FAQ 21-01: Unplanned Scrams with Complications for AP1000

Plant: Generic to AP1000 Reactors

Submittal Date: 01/27/2021

Performance Indicator: IE04, Unplanned Scrams with Complications (USwC)

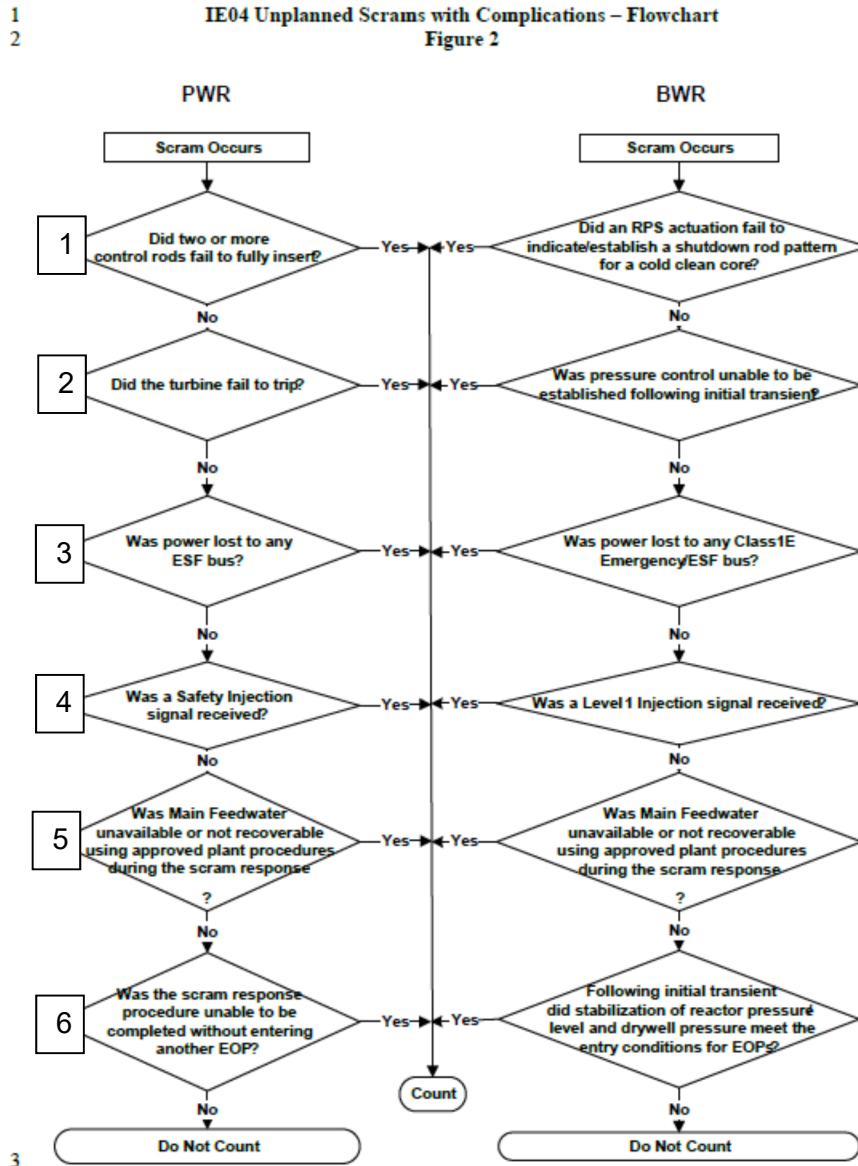
5. Conforming changes are needed in the depiction of PWR scram screening questions in Figure 2, as follows:
 - a) For the third decision diamond, which reads, “Was power lost to any ESF bus?”, add the following footnote: “For AP1000: Was power lost to any battery backed Class 1E DC and UPS System (IDS) bus?”
 - b) For the fourth decision diamond, which reads “Was a Safety Injection signal received?”, add the following footnote: “For AP1000: Was a Safeguards Actuation signal received?”

See footnote³
